MAYFLOWER PLATINUM

Survey no. 82/1, Mallapur, Hyderabad – 500 076.
Owned & Developed by: M/s. Modi Properties Pvt. Ltd.
Head office; 5-4-187/3&4 M G Road Secunderabad.

Details of Additions & Alterations

Flat No	801	Block no.	'B'
Flat Area	1500 sft	Type	Deluxe / Luxury
Buyer Name	Dr. Sunkara Rajeshwara Rao/ Swarna Latha		
Phone No.	9985343292/ 7993617572	Email	Sunkara_dr2000@yahoo.com

Changes in kitchen platform: (mark on plan)

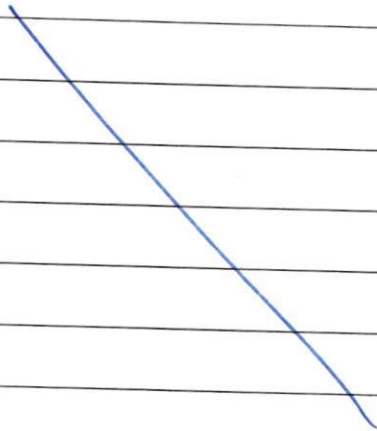
Same as MSW Plan. A 105

Utility door Enter given by kitchen room.

~~Sink should be change to the wall.~~

1) Kitchen Platform Extended.

ELECTRICAL PLAN OF FLAT-B1

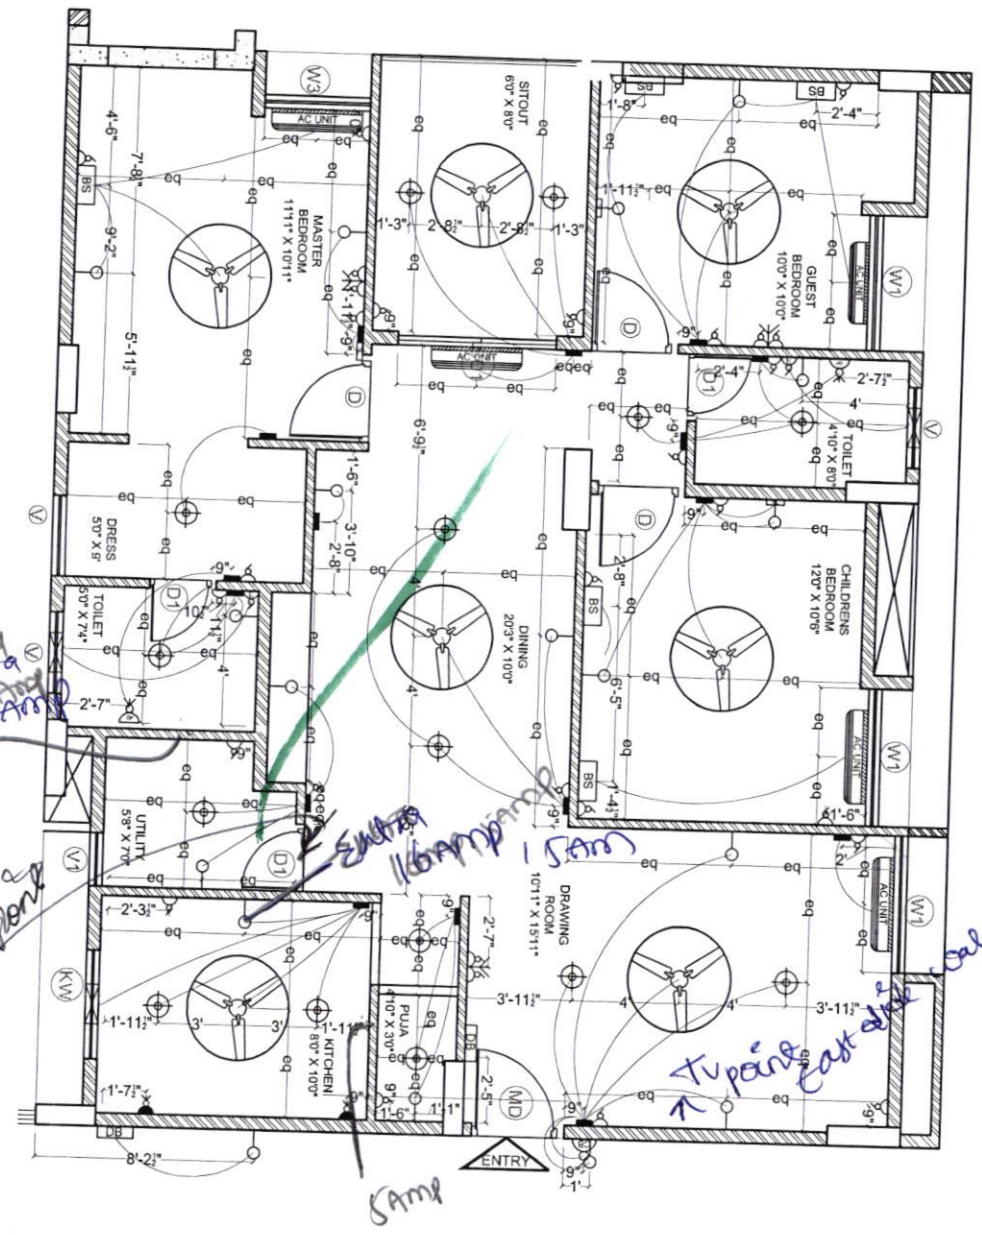
Changes in electrical points: (mark on plan)

provide two electrical points in kitchen
marked in plan.

- 1> GBR + CBR TV point extra.
- 2> Drawing / MBR internet access. (all room)
